**Re: Nogales Transmission, L.L.C. – Nogales Interconnection Project – PP 420
Application Amendment**

This letter amends the April 8, 2016, Application for a Presidential Permit for the Nogales Interconnection Project (the “Project”).

This amendment reflects an electrical reconfiguration that has been designed to make the Project more cost-effective. Conceptually, the new configuration connects the Project to the UNS Electric (“UNSE”) system at the planned Gateway Substation (“Gateway”) rather than, as originally proposed, at the existing Valencia Substation (“Valencia”). As discussed in more detail below, that connection will be accomplished by severing the existing UNSE Vail to Valencia 138-kV line and connecting it to one circuit of a new double-circuit 138-kV line, to be constructed and owned by UNSE, with an origination point near Valencia and a termination point at Gateway. A second circuit on that line will originate at Gateway and terminate at an existing UNSE line near Valencia; that circuit will serve as the source for Valencia. These changes are illustrated conceptually on Attachment 1, and the specific changes are detailed below. The reconfiguration does not change th

Project Configuration Diagrams

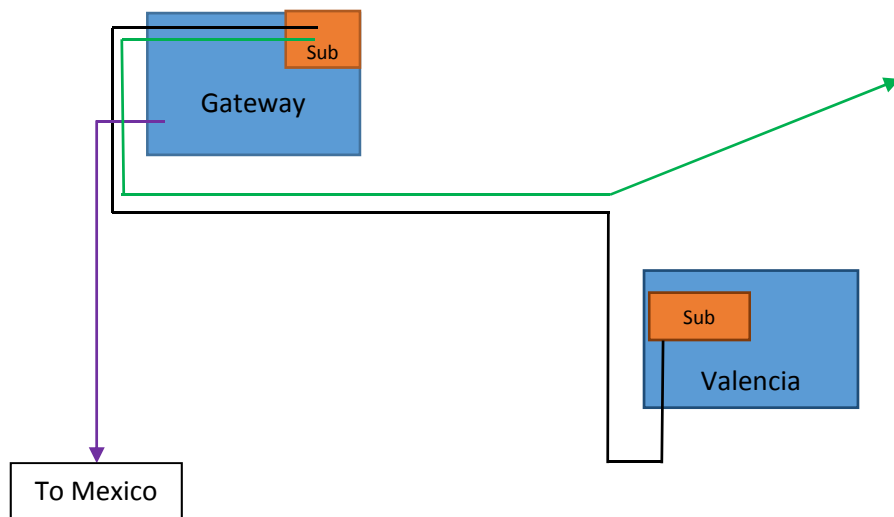
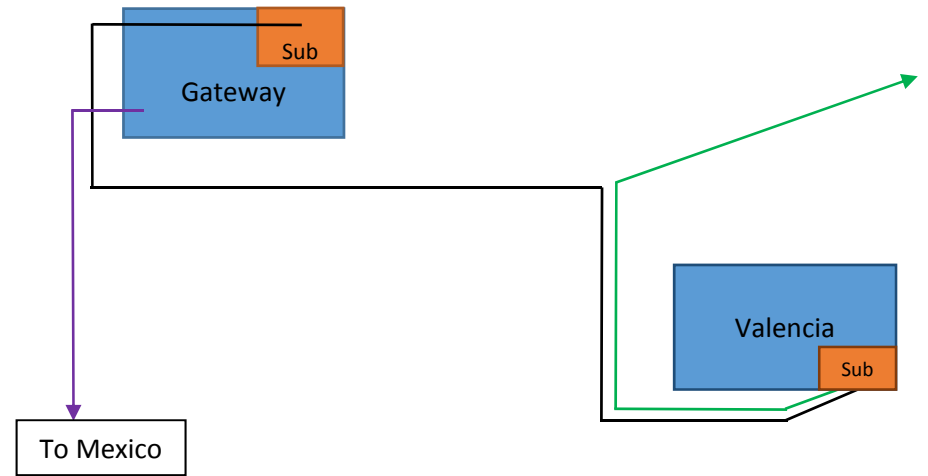
The reconfiguration would connect the Project to the UNSE transmission system at Gateway rather than at Valencia. A new, approximately 3-mile long, overhead double-circuit 138-kilovolt (kV) alternating current (AC) transmission line would be constructed on new double-circuit monopoles. The first circuit will originate at an existing pole 1,900 feet west of the existing Valencia Substation and terminate at the new Gateway Substation. At the origination point, the existing Vail to Valencia line will be severed and connected to this new line, thereby converting the existing Vail to Valencia transmission line to the “Vail to Gateway” transmission line. The second circuit will originate at the Gateway Substation and proceed in an easterly direction to a pole 1,900 feet west of the existing Valencia Substation, where it will connect with the existing portion of the UNSE 138-kV transmission line that travels east along the north side of W. White Park Drive to the Valencia Substation. This circuit will constitute the new “Gateway to Valencia” transmission line. The reconfiguration is shown on a map at Attachment 2, and a one-line diagram of the reconfiguration is provided at Attachment 3.

Project One-Line Diagram

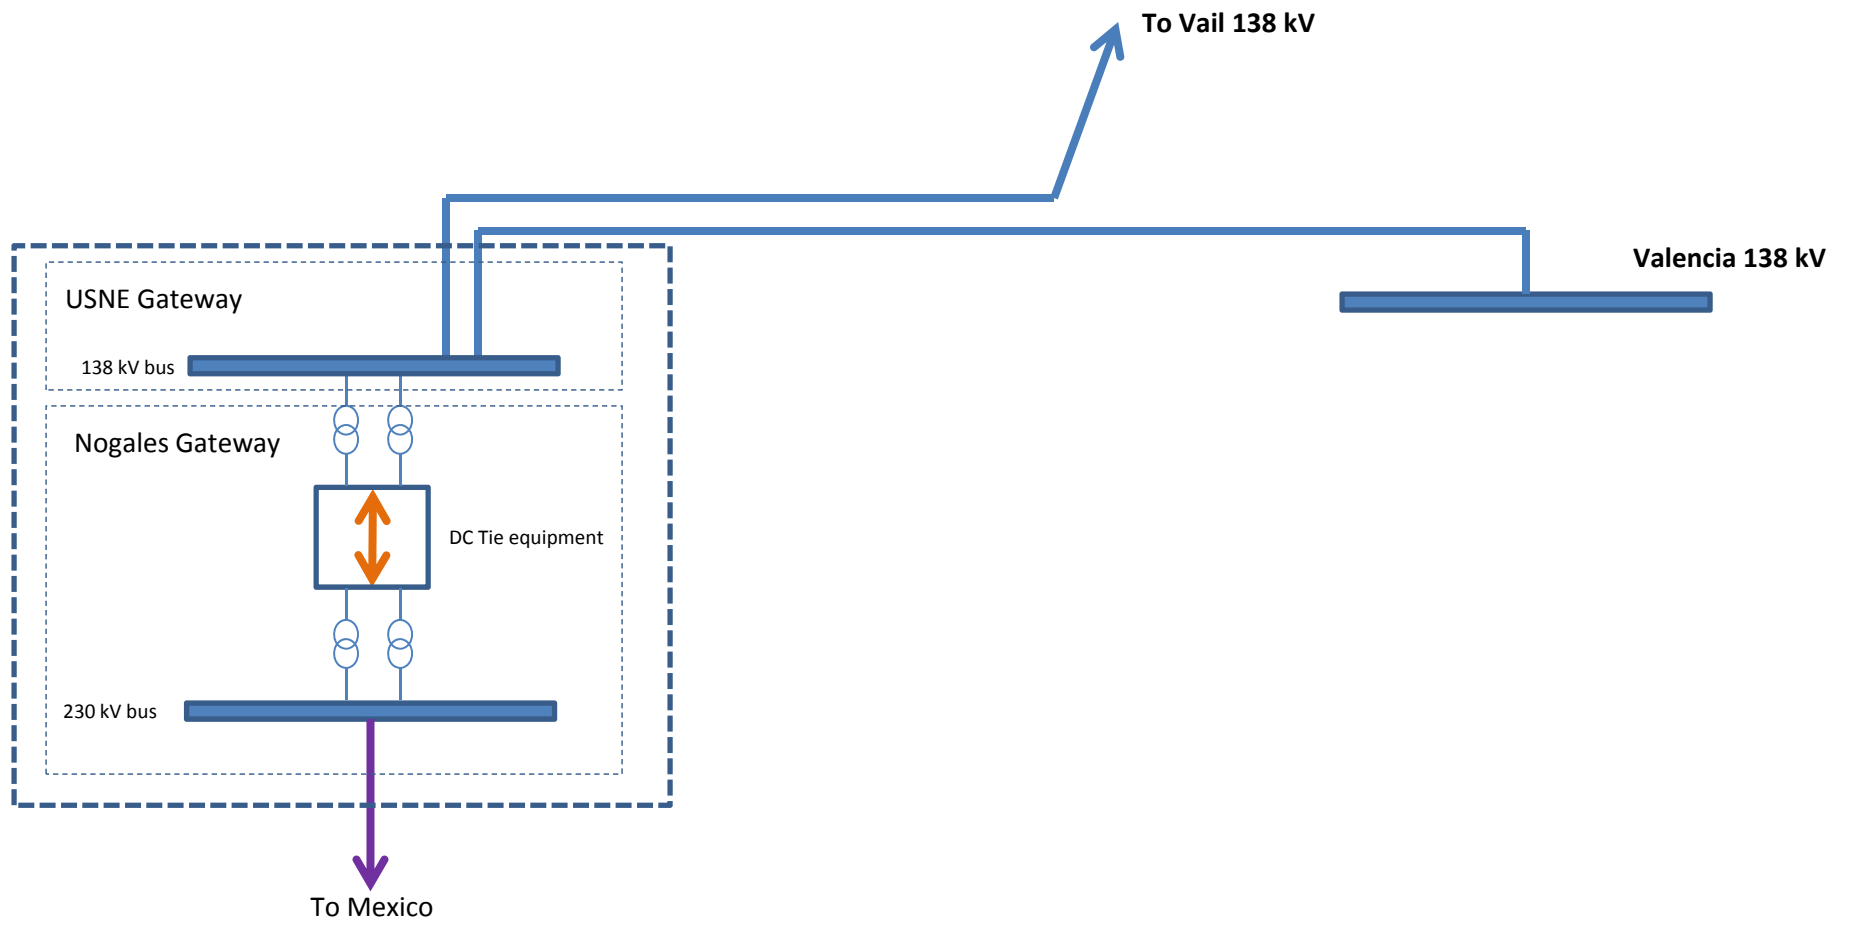
Under the new configuration, there will be only minor modifications relating to relaying equipment at the existing UNSE Valencia Substation; those modifications are necessary to accommodate the connection from the proposed 138-kV transmission line from Gateway to Valencia. Because the UNSE transmission line will now terminate at Gateway, in addition to the Gateway Substation envisioned in the original Application, a new approximately 1.8-acre UNSE 138-kV Gateway Substation will be constructed on the eastern edge of the Gateway site. This substation will consist of a three-bay, breaker and a half, open-air configuration that will accommodate the line from Vail, the line to Valencia, the connection to the DC converter and a future UNSE distribution transformer.

Alternative 1 – Original vs Alternate Configuration

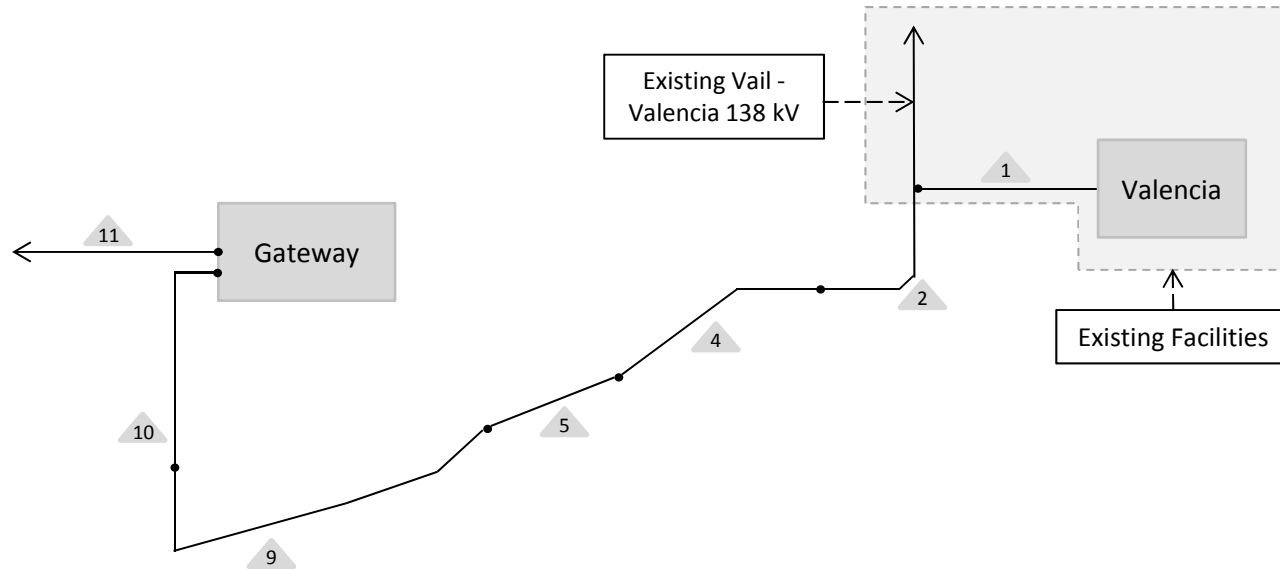
Segment	Original Configuration	Alternate Configuration
Valencia	Rebuild required	No rebuild required
1	Double-circuit 138kV on existing double-circuit poles	Single-circuit 138kV on existing double-circuit poles
2/4/5/9/10	Single-circuit 138kV on double-circuit poles	Double-circuit 138kV on double-circuit poles. Adding a second circuit does not impact pole height.
11/13/15	Single-circuit 230kV on double-circuit poles	No change
Gateway	Expansion and buildout	Same, with incremental 138kV facilities
ROW Width	150'	No change
ROW length	Approximately 5.8 miles	No change
Access Roads	3.08 miles of Access Type A and 0.24 mile of Access Type B, and require the upgrade of 3.22 miles of Access Type C roads. Additionally, 2.27 miles of Access Type D and 0.49 mile of Access Type E roads would be constructed.	No change

Alternative 2 – Original vs Alternate Configuration

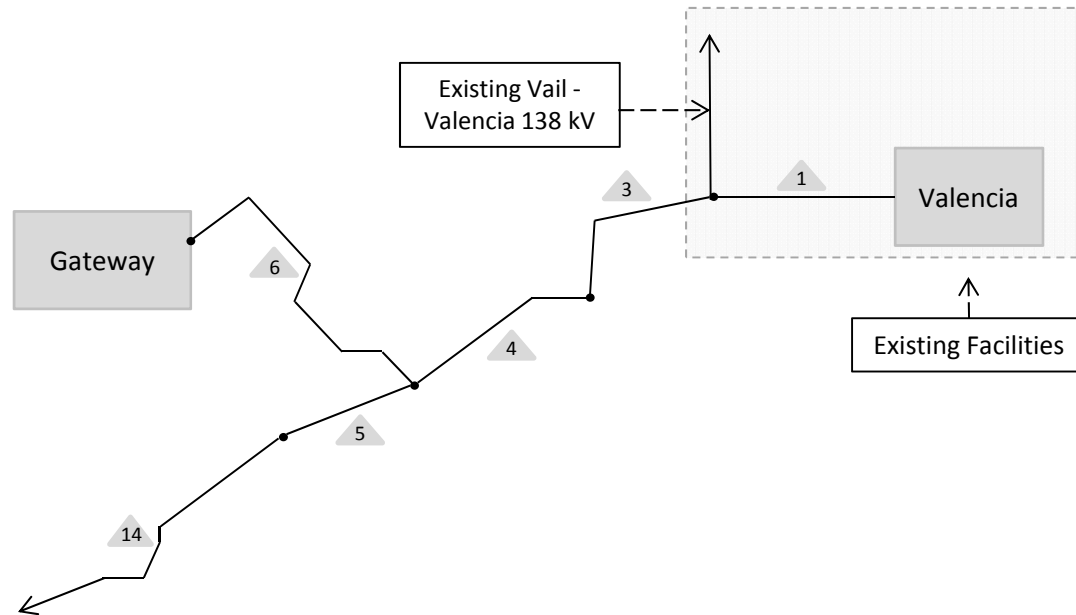
Segment	Original Configuration	Alternative Configuration
Valencia	Rebuild required	No rebuild required
1	Double-circuit 138kV on existing double-circuit poles	Single-circuit 138kV on existing double-circuit poles
3/4	Single-circuit 138kV on double-circuit poles	Double-circuit 138kV on double-circuit poles. Adding a second circuit does not impact pole height.
6	One circuit 230kV, one circuit 138kV on double-circuit poles; Seven poles with an average height of ~115 feet.	One circuit 230kV, two circuits 138kV on triple-circuit capable poles; Seven poles with an average height of ~140 feet.
5/14/15	Single-circuit 230kV on double-circuit poles	No change
Gateway	Expansion and buildout	Same, with incremental 138kV facilities
ROW Width	150'	No change
ROW length	Approximately 4.9 miles	No change
Access Roads	1.57 miles of Access Type A and 0.86 miles of Access Type B, and require the upgrade of 1.60 miles of Access Type C roads. Additionally, 2.00 miles of Access Type D and 0.38 mile of Access Type E roads would be constructed.	No change

Alternative 3 – Original vs Alternate Configuration

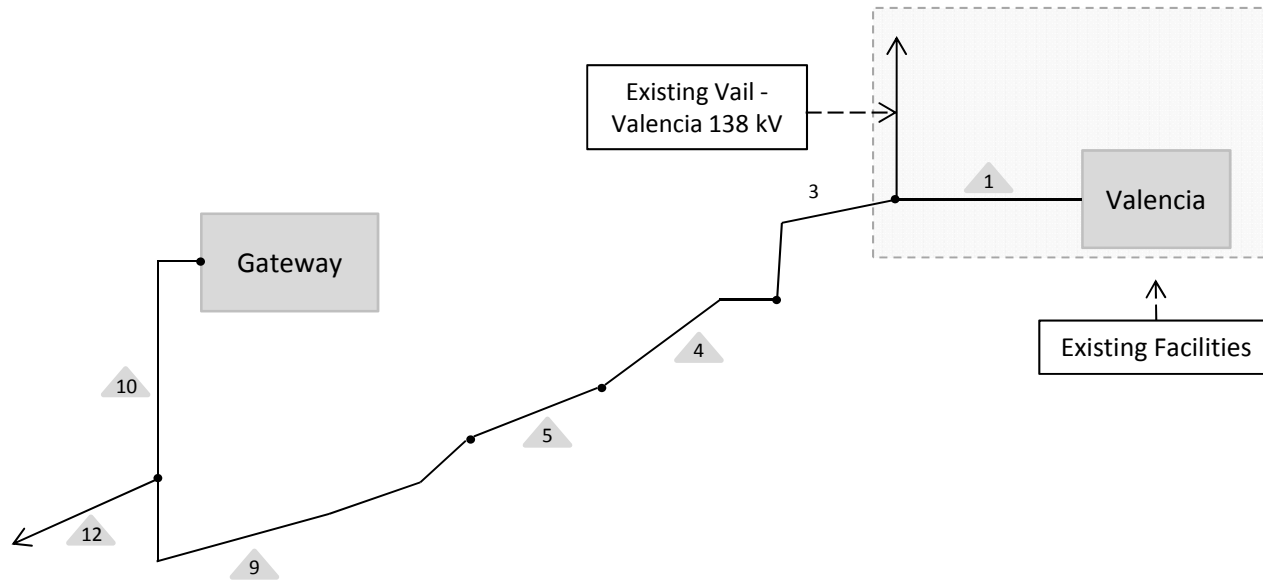
Segment	Original Configuration	Alternative Configuration
Valencia	Rebuild required	No rebuild required
1	Double-circuit 138kV on existing double-circuit poles	Single-circuit 138kV on existing double-circuit poles
3/4/5/9	Single-circuit 138kV on double-circuit poles	Double-circuit 138kV on double-circuit poles. Adding a second circuit does not impact pole height.
10	One circuit 230kV, one circuit 138kV on double-circuit poles; Five poles with an average height of ~110 feet.	Single-circuit 230kV on double-circuit poles, double-circuit 138kV on double-circuit poles; Twelve poles with an average height of ~100 feet.
12/13/15	Single-circuit 230kV on double-circuit poles	No change
Gateway	Expansion and buildout	Same, with incremental 138kV facilities
ROW Width	150'	No change
ROW length	Approximately 5.1 miles	No change
Access Roads	2.23 miles of Access Type A and 0.76 miles of Access Type B, and require the upgrade of 2.60 miles of Access Type C roads. Additionally, 1.97 miles of Access Type D and 0.26 mile of Access Type E roads would be constructed.	Same, with incremental 0.3 miles of Type E roads (spur roads).

Alternative 4 – Original vs Alternate Configuration

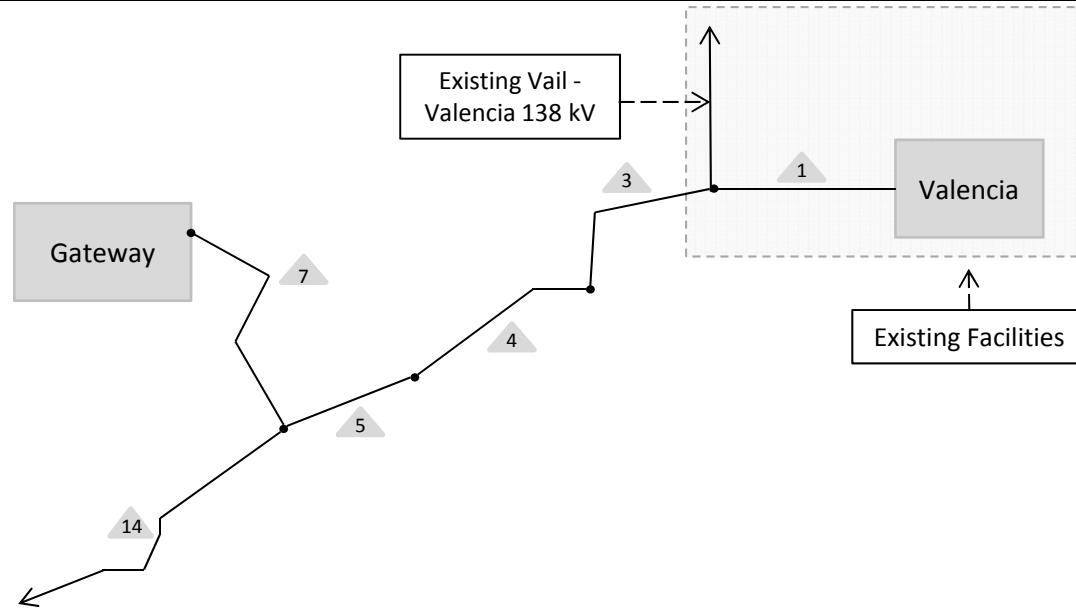
Segment	Original Configuration	Alternative Configuration
Valencia	Rebuild required	No rebuild required
1	Double-circuit 138kV on existing double-circuit poles	Single-circuit 138kV on existing double-circuit poles
3/4/5	Single-circuit 138kV on double-circuit poles	Double-circuit 138kV on double-circuit poles. Adding a second circuit does not impact pole height.
7	One circuit 230kV, one circuit 138kV on double-circuit poles; Five poles with an average height of ~115 feet.	Double-circuit 138kV line on double-circuit poles on one side of Mariposa Ranch Road and one 230 kV circuit line on double-circuit capable structures on the opposite side of Mariposa Ranch Road. Ten poles with an average height of ~105 feet.
14/15	Single-circuit 230kV on double-circuit poles	No change
Gateway	Expansion and buildout	Same, with incremental 138kV facilities
ROW Width	150'	No change
ROW length	Approximately 4.6 miles	No change

Access Roads	1.60 miles of Access Type A and 1.15 miles of Access Type B, and require the upgrade of 1.26 miles of Access Type C roads. Additionally, 2.04 miles of Access Type D and 0.26 mile of Access Type E roads would be constructed.	Same, with incremental 0.4 miles of Type E roads (spur roads).

Relevant for Alternative 2: Typical Arrangement of triple circuit capable poles within 150' ROW, Segment 6

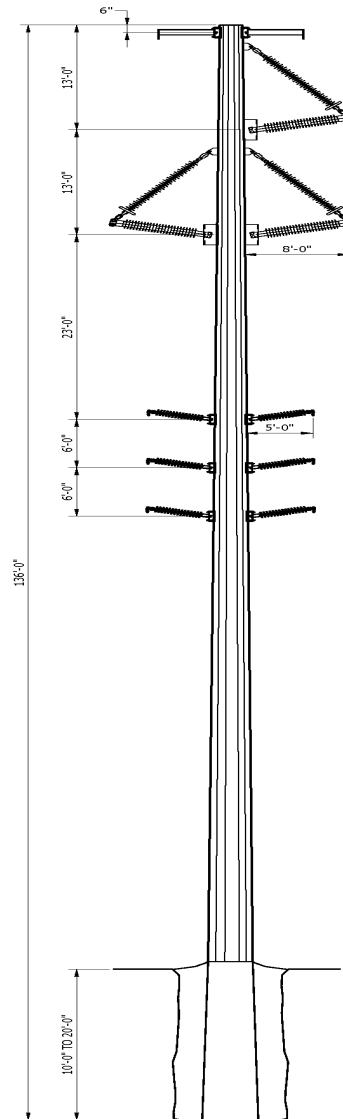
There would be changes to the tower configuration for route segments 6, 7 and 10. As noted above, route segment 6 would utilize a triple-circuit transmission line configuration, and route segments 7 and 10 would utilize double-circuit 138-kV transmission line and one 230-kV single-circuit on double-circuit capable structures in the same corridor. A conceptual arrangement for those tower configurations is provided at Attachment 5.
